Technical Bulletin

Bulletin No: TCH-002-008

Subject: New Bendix® “Welded Clevis” Spring Brake Chamber

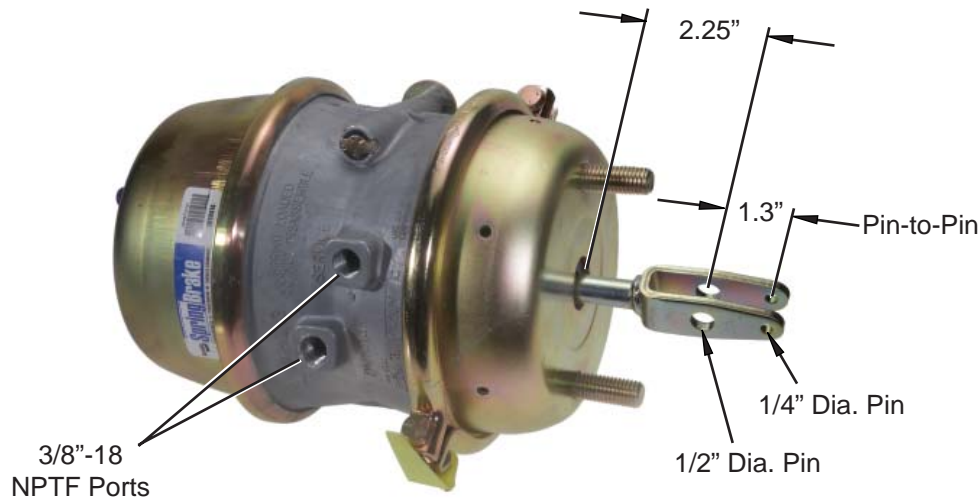
Note: The 1.3 inch pin-to-pin dimension on the welded clevis allows it to be used with single and double clevis pin slack adjusters in applications requiring the dimensions shown here. The Bendix® ASA-5® Slack Adjuster requires a clevis pin-to-pin dimension of 1.0 inch; therefore, it can not be used with the spring brake chambers shown here.
